DESIGN <i>KE</i>	DRAWN BY <i>KE</i>	DART AEROSPACE LTD HAWKESBURY, ONTARIO, CANADA	
CHECKED <i>DM</i>	APPROVED <i>JA</i>	DRAWING NO. DSI 9101	REV. A SHEET 1 OF 1
DATE 98.04.30		TITLE BOLT LENGTH ADJUSTMENT	SCALE NTS
A	98.04.30	NEW ISSUE

DART SERVICE INSTRUCTION

AMEND INSTALLATION INSTRUCTIONS IIN-D206-628 REV. B
US STC: SA00500SE

TYPICAL WASHER STACKING EXAMPLE

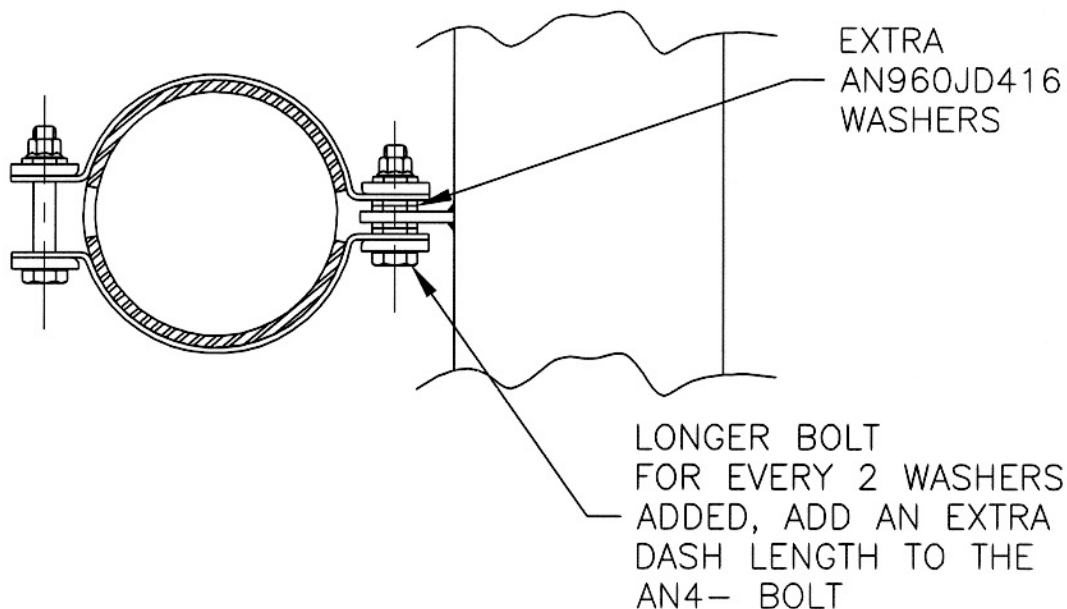
AN960JD416 WASHERS MAY BE ADDED BETWEEN CLAMPS ON THE
INBOARD SIDE TO ACCOMODATE VARYING CROSSTUBE DIAMETERS.

REFER TO EXAMPLE BELOW
